## ZÁVAZNÝ SERVISNÍ BULETIN / MANDATORY SERVICE BULLETIN

TÝKÁ SE / CLARIFICATIONS: Damage to the flap drive torque tube in the fuselage.

OVLIVNĚNÉ VÝROBKY / AFFECTED PRODUCTS: TL 3000 Sirius serial numbers

ČÍSLO BULETINU / NOTICE ID: 3.S.SI.2017

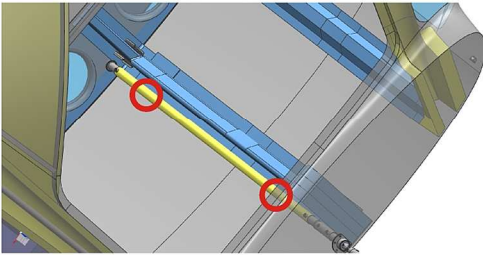
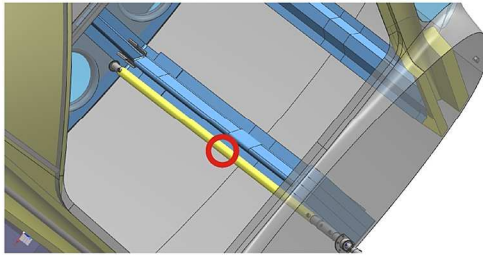
Sequence of steps	Description of Operation
<p><b>1</b></p>	<p><b>Aircraft preparation</b></p> <ul style="list-style-type: none"> <li>- Move the plane into a suitable work area and fix wheel chocks</li> <li>- Make sure that all switches are off and the rescue system is secured against activation.</li> </ul>
<p><b>2</b></p>	<p><b>Dismantling of overhead instrument panel</b></p> <ul style="list-style-type: none"> <li>- Remove the overhead instrument panel from the ceiling panel (if the aircraft has an overhead instrument panel). The instrument panel is secured to the composite roof panel with seven M4x12 screws (cross headed). The instrument panel will remain suspended from the ceiling of the aircraft on the cables from the instruments.</li> </ul> 
<p><b>3</b></p>	<p><b>Dismantling fuel gauge panel</b></p> <ul style="list-style-type: none"> <li>- Remove both fuel gauges mounted on the sides of the composite ceiling panel. The sheets are fastened to the ceiling panel using four M4x12 screws (countersunk head with cross-slot).</li> </ul>

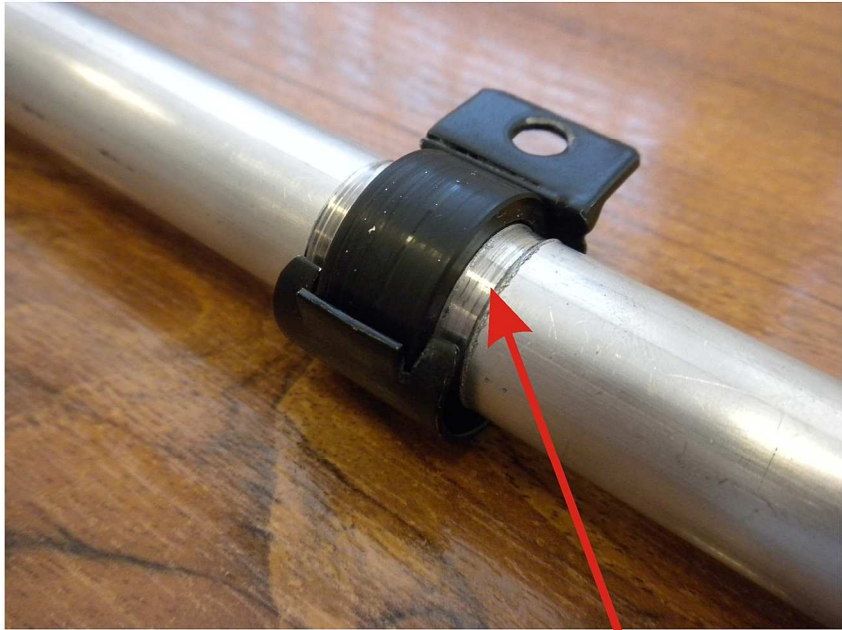
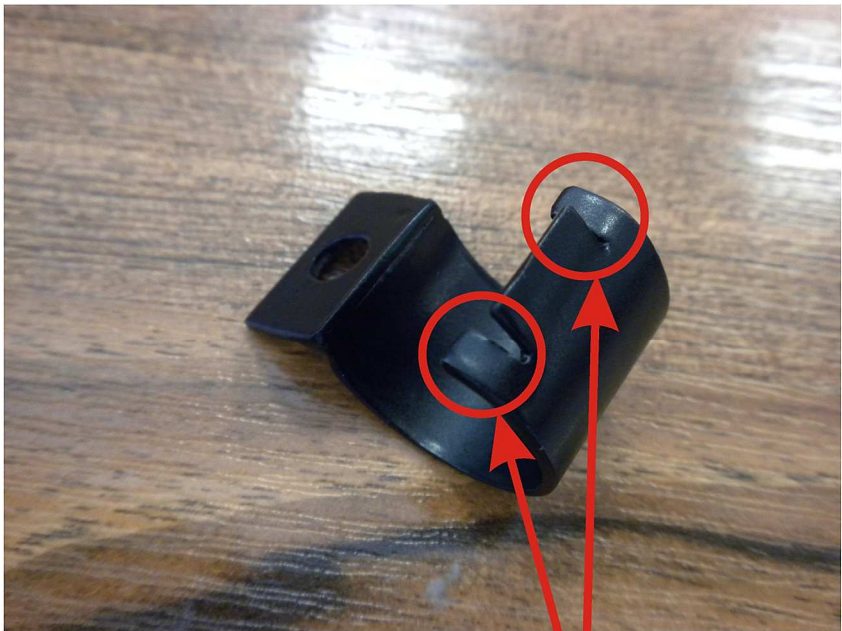
Sequence of steps	Description of Operation
	<div style="display: flex; flex-direction: column; align-items: center;">  <p style="margin-top: 20px;">1 ... Composite ceiling panel                  2 ... Transparent fuel gauge cylinder                  3 ... Internal part of the fuel gauge                  4 ... Outer metal part of the fuel gauge                  5 ... M4x12 screw</p> </div>
